Wisconsin Department of Transportation

Proposal #24: 6933-00-61, WISC 2025115
Nekoosa – Babcock
Culvert Replacement
STH 173
Wood County

6933-00-77, WISC 2025116
Nekoosa – Babcock
STH 80 NB to Cranberry Bridge
STH 173
Wood County

This is Addendum No. 02, which provides for the following:

Addendum No. 02
ID 6933-00-61/77
Revised Sheet 37
December 6, 2024

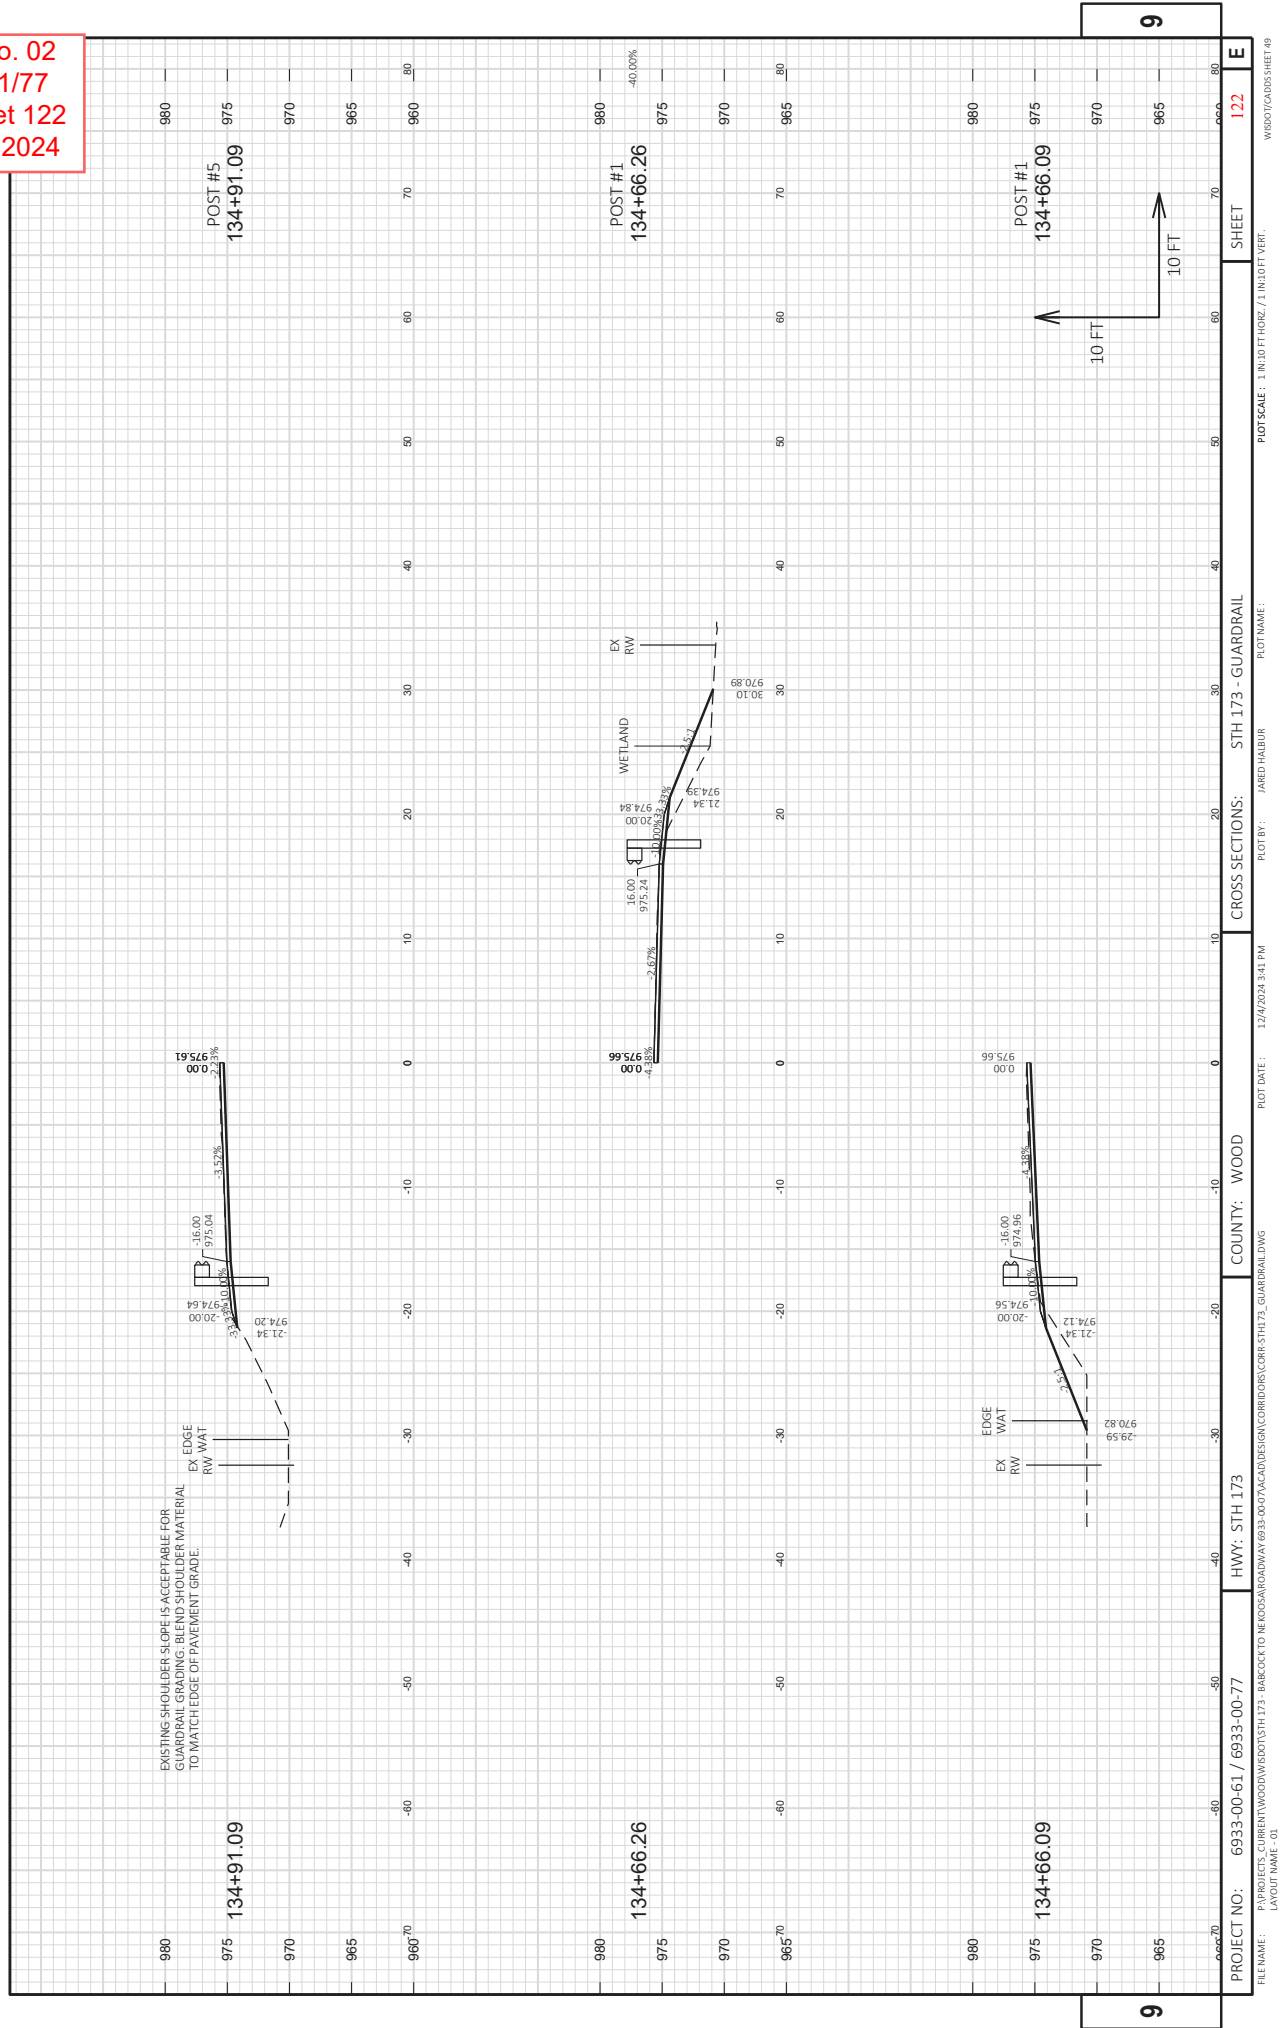
Revised Plan Sheets	
Plan Sheet	Plan Sheet Title (brief description of changes to sheet)
12	Construction Details (Revised guardrail layout to tie into existing rail system on box culvert)
18	Construction Details (Label on proposed cross culvert)
19	Construction Details (Label on proposed cross culvert)
34	Miscellaneous Quantities (Asphaltic Items Bid Items)
35	Miscellaneous Quantities (Concrete Surface Drains and Concrete Curb and Gutter Bid Item)
36	Miscellaneous Quantities (Beamguard Items Bid Items)
37	Miscellaneous Quantities (Traffic Control Items Bid Items)
122 - 127	Cross Sections (Revised guardrail cross sections for updated layout)
